INDEX			
CIRCULARS			
SL.NO.	DETAILS OF CIRCULAR	DATED	PAGE NO.
1	ACCEPTANCE OF BANK GUARANTEES.	08.04.2008	2
2	VENDOR LIST FOR APPROVED MAKE OF MATERIAL & EQUIPMENT FOR RO's.	13.11.2008	4
3	GUIDELINES FOR LABORATORIES FOR TESTING OF CONSTRUCTION MATERIAL	18.11.2008	5
4	PREVENTION OF FIRE ACCIDENTS AT RETAIL OUTLETS	24.11.2008	6
5	DRAWINGS FOR RVI WORKS	19.12.2008	8
6	ISSUANCE OF WORK ORDERS	24.12.2008	51
7	EFFECT OF PUTTING A PARTY ON HOLIDAY LIST - ADDITIONAL SITUATIONS	20.02.2009	52
8	REDUCTION IN SERVICE TAX	24.02.2009	54
9	PROVISION OF SADDLE PLATE FOR PIPELINE	10.03.2009	55
10	PREPERATION OF FINAL BILLS & CLOSURE OF WORK ORDERS	13.03.2009	59
11	SEQUENCE ON DISPLAY PANEL OF MAIN SIGN POLE	09.03.2009	60
12	STANDARIZATION OF SPECIFICATION FOR SEAL ON FR TANKS	15.04.2009	61
13	FIRE SCREEN WALL	17.04.2009	65
14	ENGRAVING THE NAMES OF PROJECT IN CHARGE AT SITE	21.04.2009	66
15	FINAL APPROVAL FOR PROVISION OF HIGH MAST SIGNAGE 17M/22M HIGH	18.05.2009	67

16	STANDARD DRAWINGS OF 20 & 70 KL TANKS ON AVIATION SERVICE	19.05.2009	70
17	FLEXIBLE PIPING BY OILCO SERVICES(NOT TO USE UPP F.P. OF OILCO)	11.06.2009	78
18	FLEXIBLE PIPING BY L&T(NOT TO USE KPS F.P. OF L&T)	15.06.2009	80
19	DELET

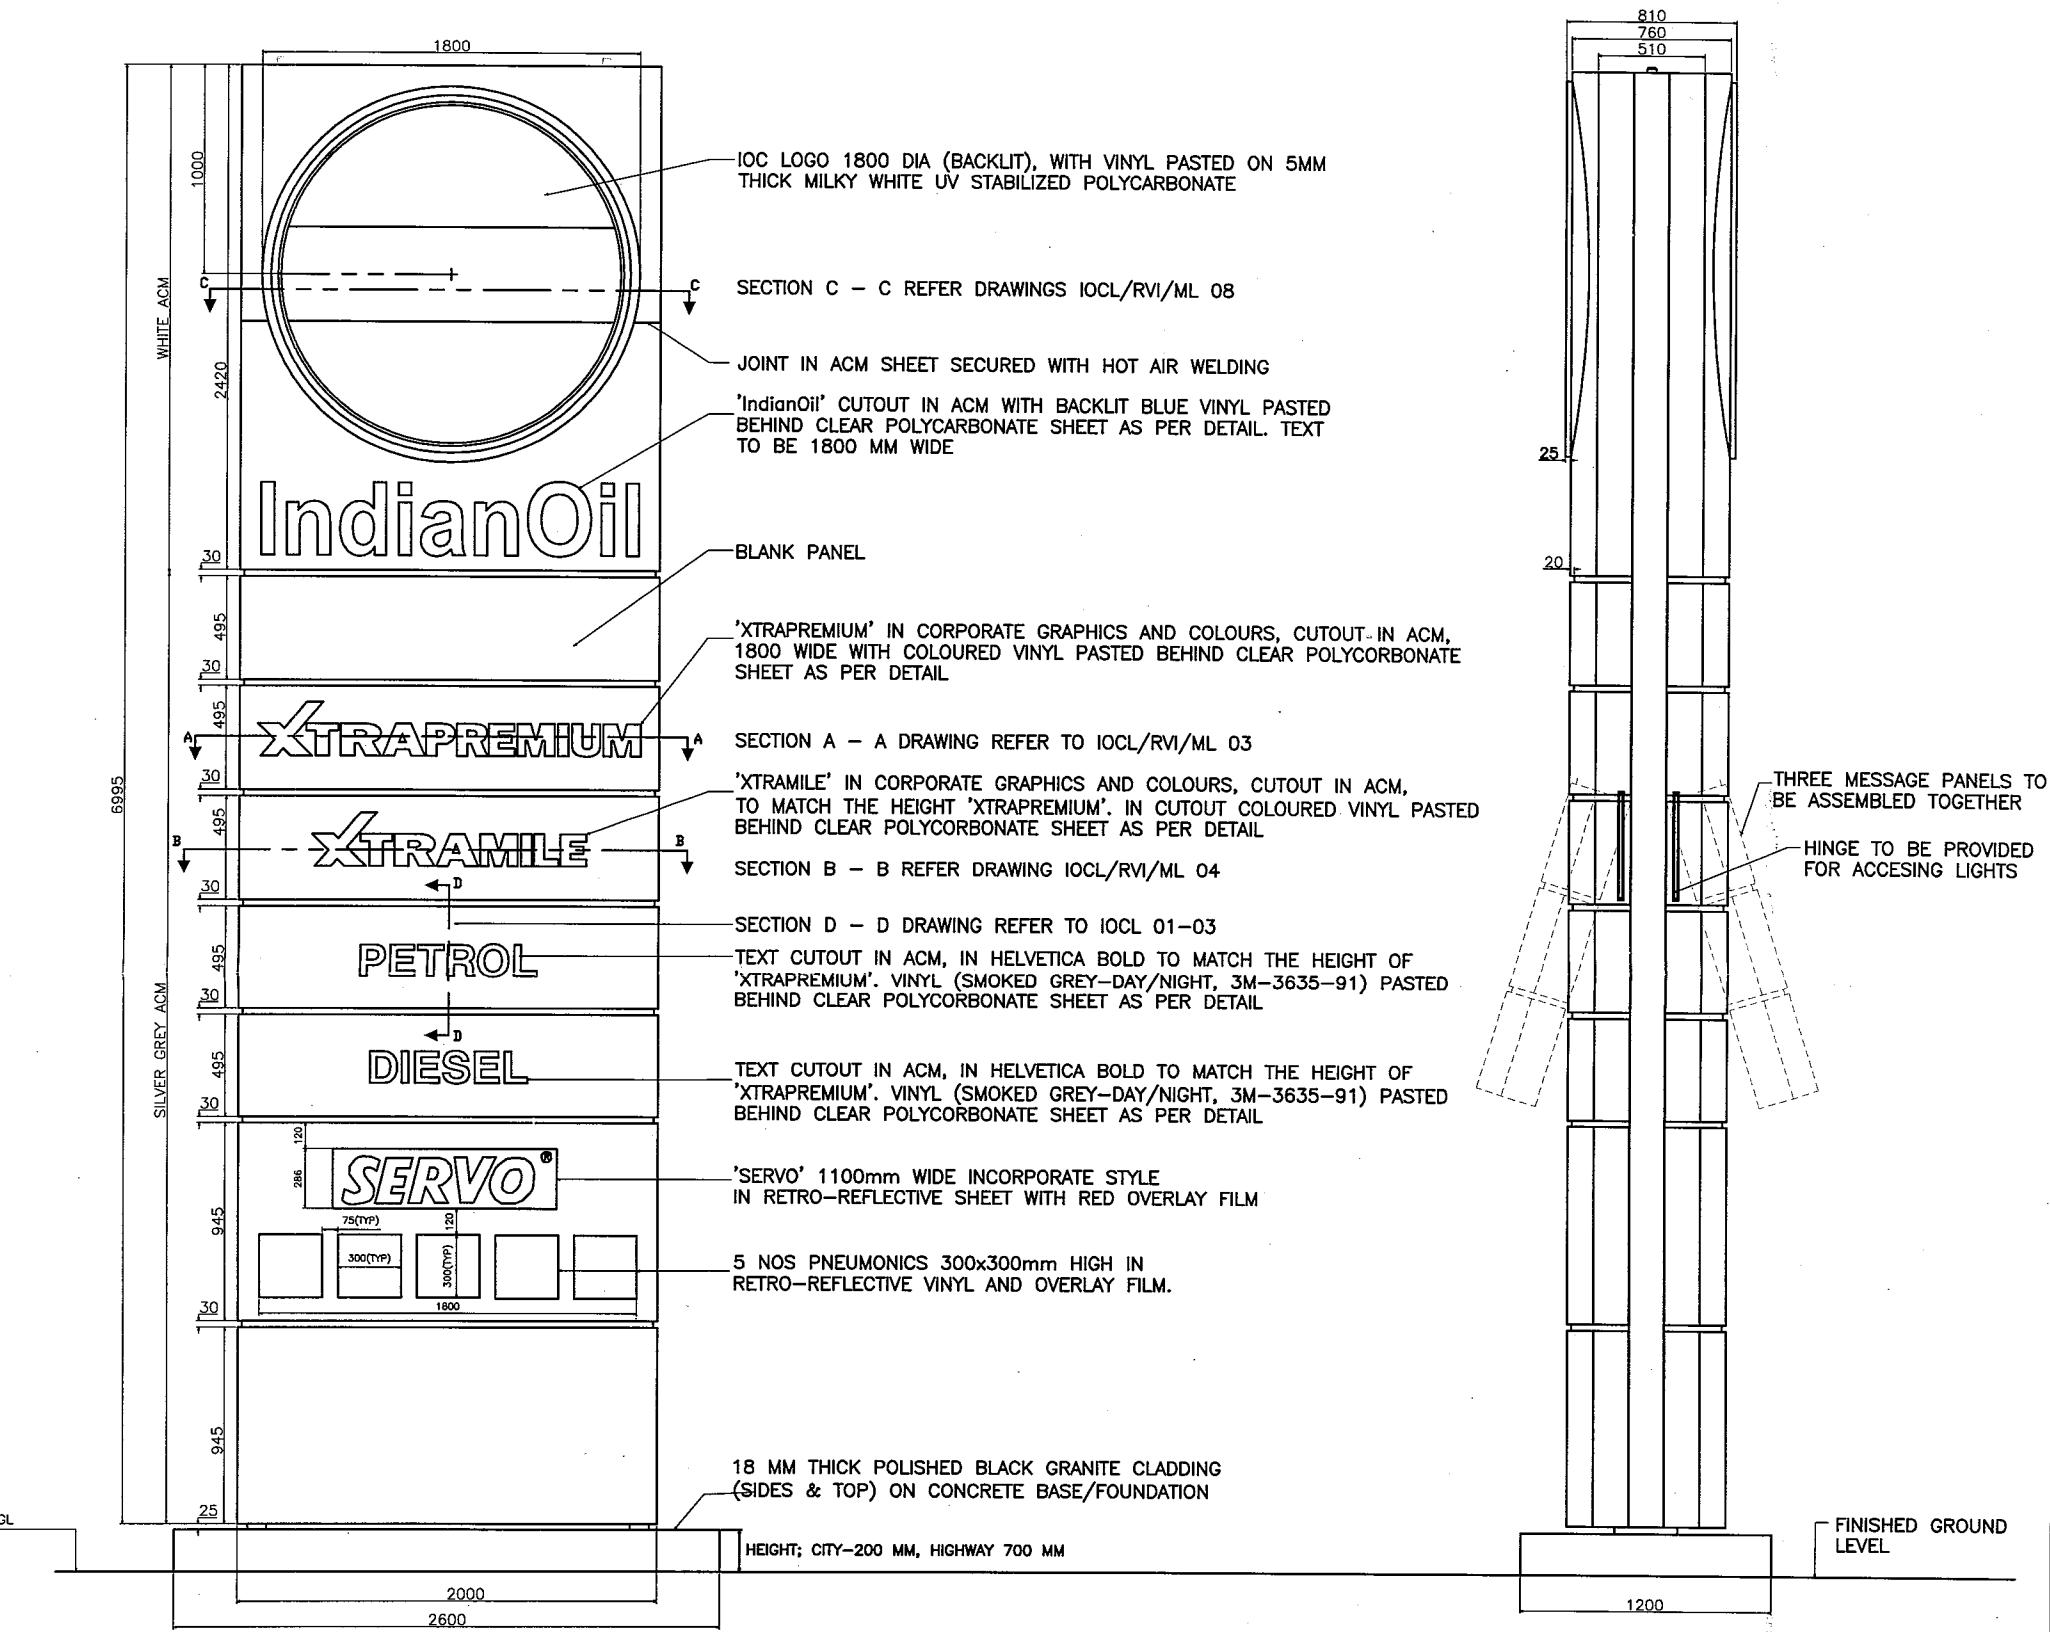
1	26.03.08	XTRACARE REPLACED WITH A BLANK PANEL
S.NO.	DATE	REVISION DETAILS
REVISION		
INDIAN OIL CORPORATION LIMITED 'INDIANOIL BHAVAN' G-9, ALI YAVER JUNG MARG, BANDRA (EAST), MUMBAI - 400 051		
RVI ELEMENTS		
TITLE: MONOLITH - FRONT & SIDE ELEVATION		
CHKD. BY: <i>[Signature]</i>		
APPD. BY: <i>[Signature]</i>		
DRN. BY: SHREE ENGINEERS		
DRAWING NO: IOCL-RVI-ML 01 / R1		
SCALE: -		
SHEET: 1 OF 3

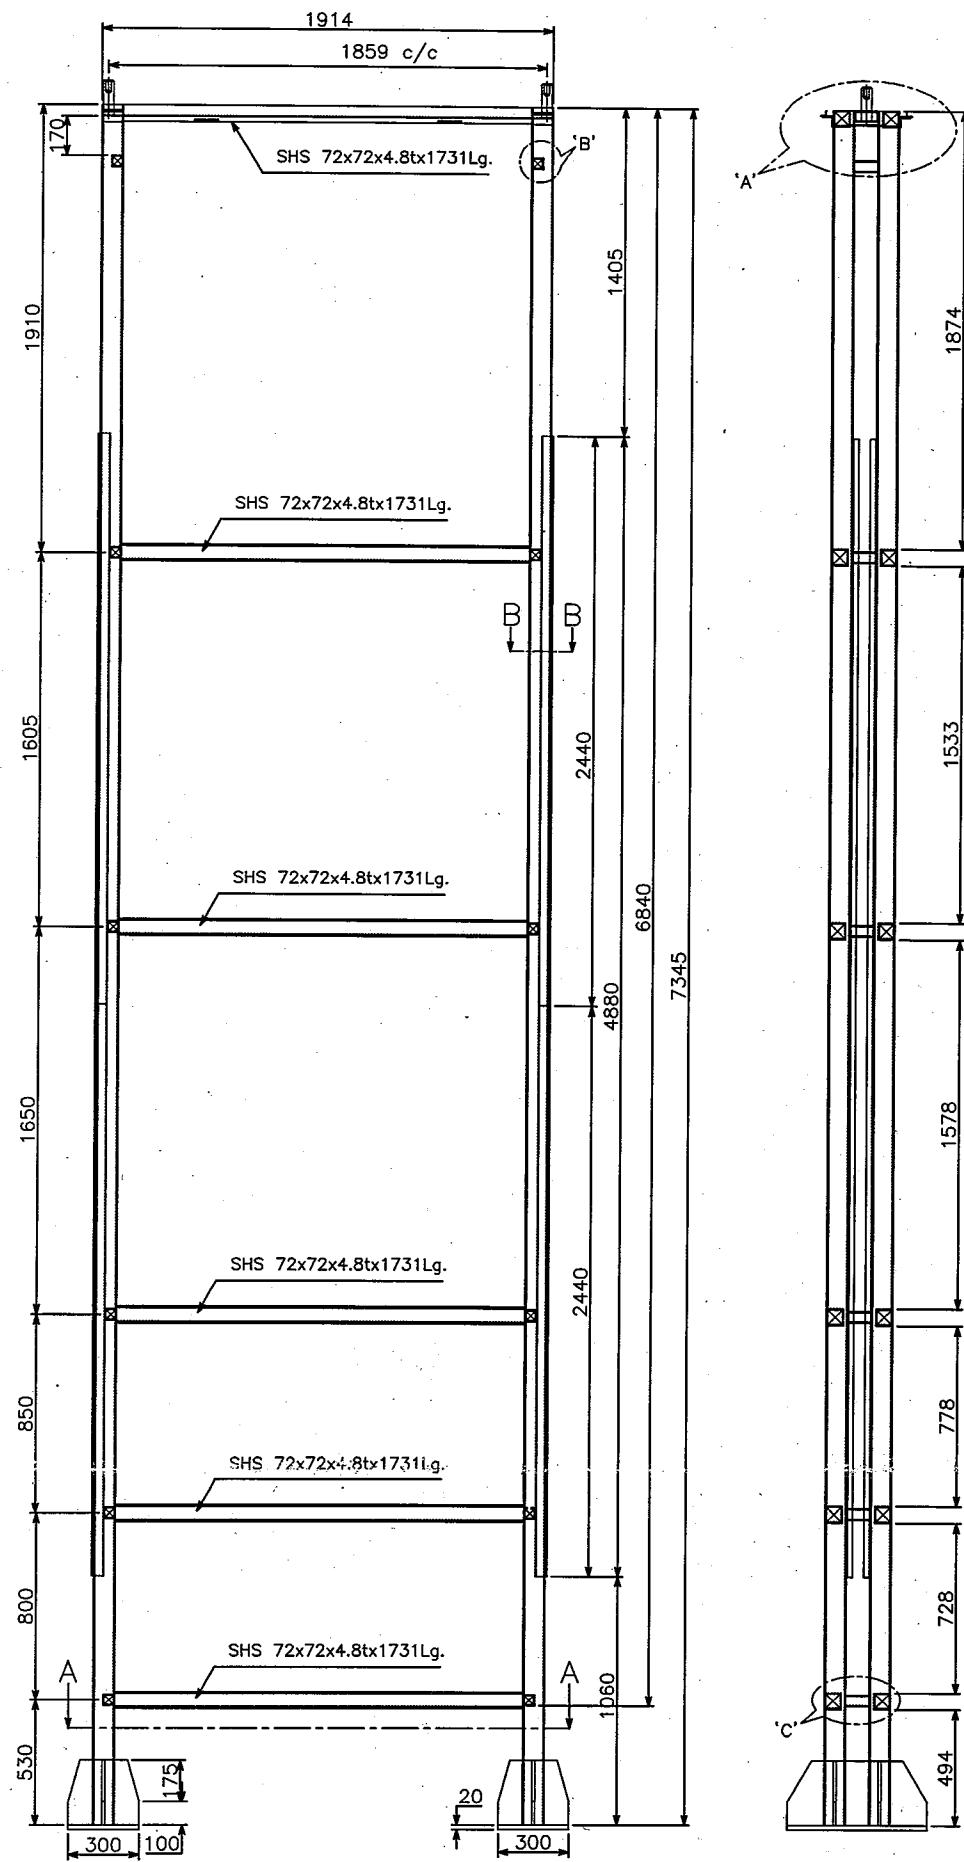
1	26.03.08	CHANGE IN OVERALL HEIGHT
S.NO.	DATE	REVISION DETAILS
REVISION		
INDIAN OIL CORPORATION LIMITED 'INDIANOIL BHAVAN' G-9, ALI YAVER JUNG MARG, BANDRA (EAST), MUMBAI - 400 051		
RVI ELEMENTS		
TITLE: MONOLITH - STRUCTURAL DETAILS		
CHKD. BY:	<i>Pint</i> <u>214108</u>	DATE: 26.03.2008
APPD. BY:		
DRN. BY : SHREE ENGINEERS		SCALE: --
DRAWING NO: IOCL-RVI-ML 02 / R01		SHEET : 2 OF 2

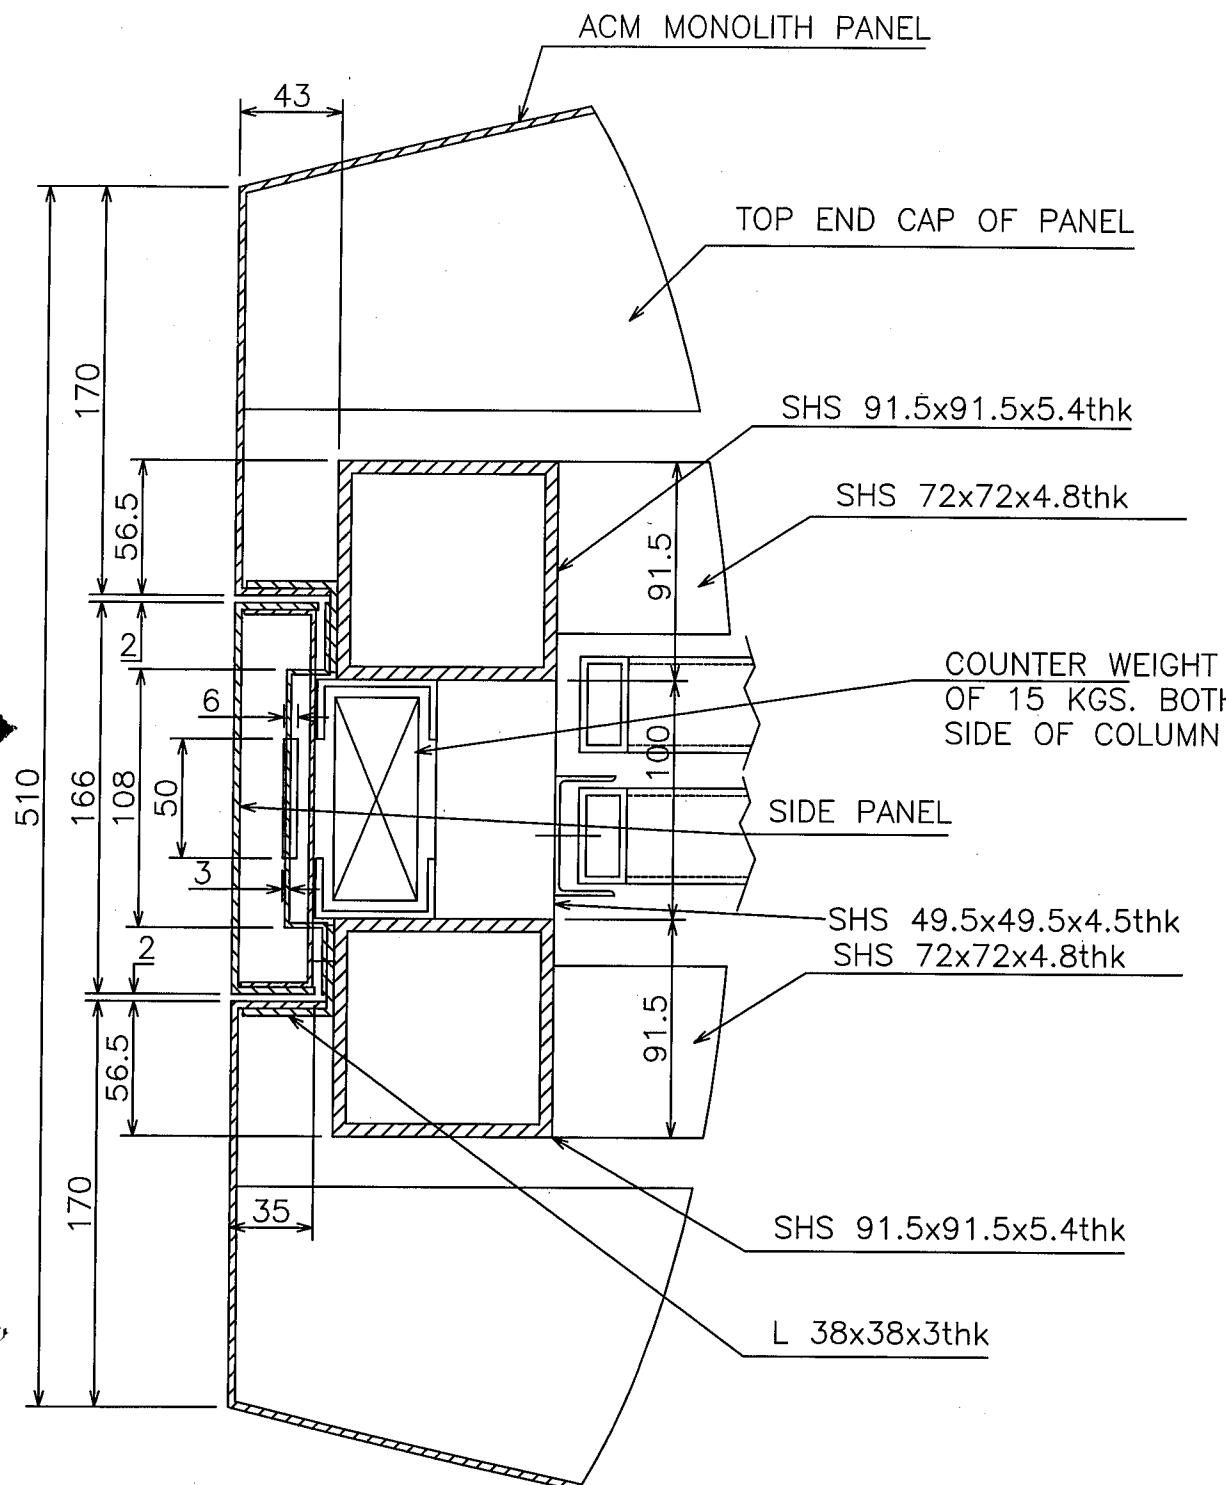
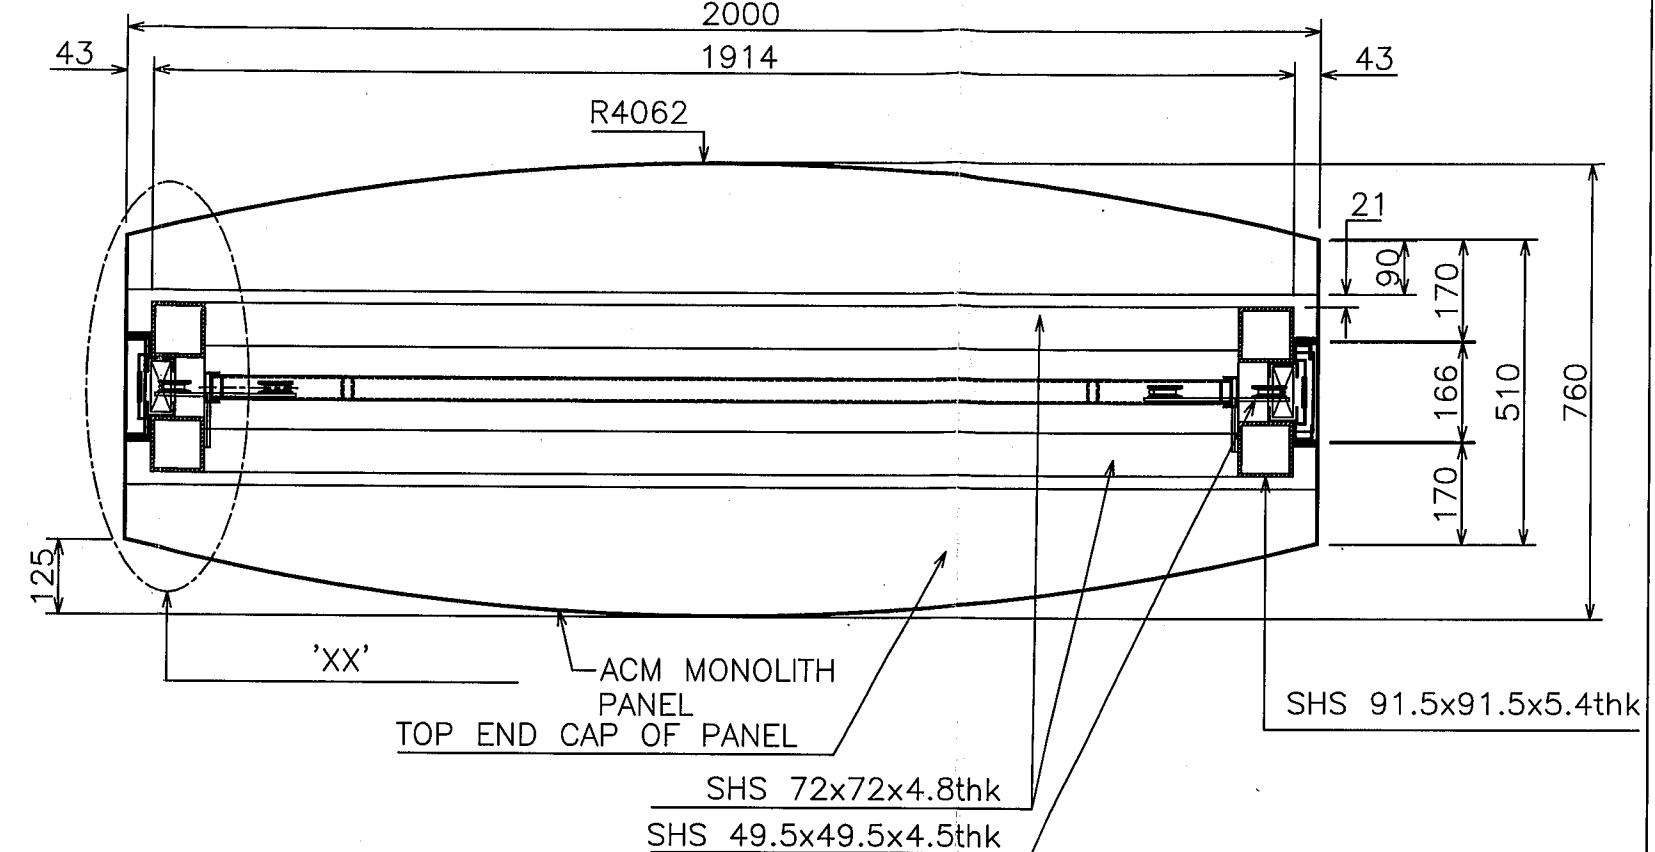
1	26.03.08	DETAILS OF 'Z' BRACKET ADDED
S.NO.	DATE	REVISION DETAILS
REVISION		
INDIAN OIL CORPORATION LIMITED 'INDIANOIL BHAVAN' G-9, ALI YAVER JUNG MARG, BANDRA (EAST), MUMBAI - 400 051		
RVI ELEMENTS		
TITLE: MONOLITH SECTION A-A VIEW		
CHKD. BY:	<u>P.S.</u> - 21/10/08	DATE: 26.03.2008
APPD. BY:	<u>DGM</u> 21/10/08 DGM (E)	
DRN. BY :	SHREE ENGINEERS	SCALE: --
DRAWING NO:	IOCL-RVI-ML 03 / R1	SHEET : 1 OF 1

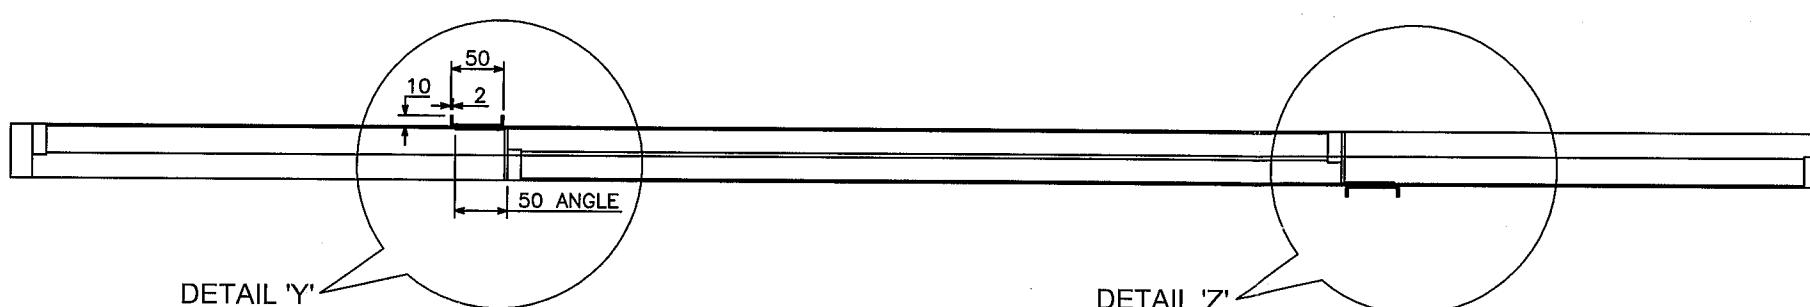
1	26.03.08	DETAILS OF PRICE DISPLAY WINDOW DELETED
S.NO.	DATE	REVISION DETAILS
REVISION		
INDIAN OIL CORPORATION LIMITED 'INDIANOIL BHAVAN' G-9, ALI YAVER JUNG MARG, BANDRA (EAST), MUMBAI - 400 051 		
RVI ELEMENTS		
TITLE:		
MONOLITH - TUBE LIGHT MOUNTING FRAMES		
CHKD. BY:	 <small>26/03/08</small>	
APPD. BY:	 <small>27/03/08</small>	
DRN. BY : SHREE ENGINEERS	DATE: 26.03.2008	
DRAWING NO: IOCL-RVI-ML 05 / R01	SCALE: --	
	SHEET : 2 OF 2
